# Land-Rover Service Newsletter Vol. 3 No. 17

October 1970

The Rover Company Limited Service Department: Solihull, Warwickshire, England

Fig. 1 Correct fitting of rear brake shoes

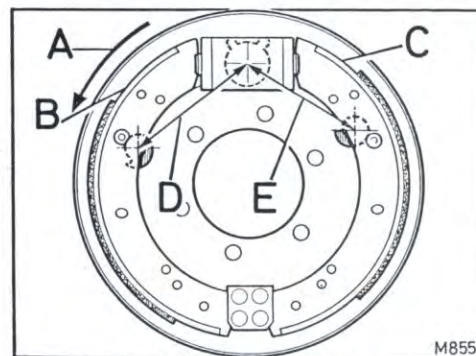
We have received reports of rear brake shoes being refitted the wrong way round, with the result that correct adjustment of the rear brakes is not possible. As shown at Fig. 1, there is a dimensional difference between the location of the shoe lining on the leading and the trailing shoes. There is also a corresponding dimensional difference in the location of the snail cams when measured from cam centre and the centre of the wheel cylinder aperture.

It is essential that rear brake shoes are fitted correctly, as illustrated, to ensure correct operation of the adjustment mechanism.

**Fig. 3 Steering relay unit**

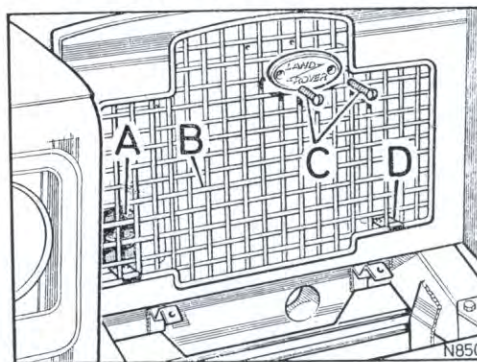
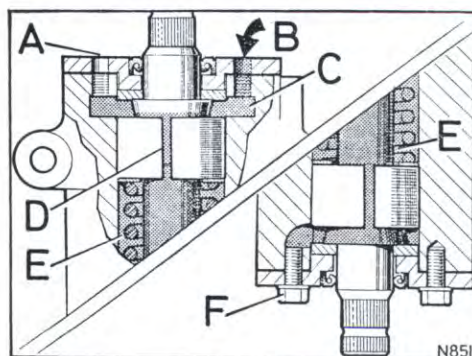
MODIFICATION: Introduction of steering relay unit oil level check at the 6.000 kms (4,000 miles) maintenance period.

REMARKS: Some cases of steering relay seizure have been found to be caused by lack of lubrication.

The relay unit oil level should therefore be checked every 6.000 kms (4,000 miles). The oil should be clearly visible through the bolt hole in the relay top cover. Top up, as necessary. If significant topping up is required, check for oil leaks and fit new joint washers as necessary. The lubricating oil should not normally need replenishing between overhauls. Full details of the unit overhaul procedure are given in Land-Rover Workshop Manual, Part Two, Part No. 606408, Operation G1-10.

2. Remove two of the bolts securing the relay top cover.
3. Using one of the holes as an oil filler (the other acting as a breather hole), fill the relay unit with the correct grade of lubricating oil to the bottom of the filler hole. Whilst filling, it is probable that oil will eject through the breather hole. If this occurs, DO NOT assume the relay unit is full. The oil has to creep through the channels between the two segments of the split bush, and this process is slow. Therefore, the upper chamber fills rapidly and oil escapes through the breather hole. Wait a few moments, until the breather hole is clear of oil, and then continue filling.

As the unit fills up, air is forced out usually in the form of an oil bubble escaping through the breather hole, again giving the impression that the unit is full. Wait for the bubble to subside, then continue filling. Continue this process, until the oil is clearly visible at the base of the breather hole and the filler hole. It takes approximately six minutes to completely fill a relay unit using this method.
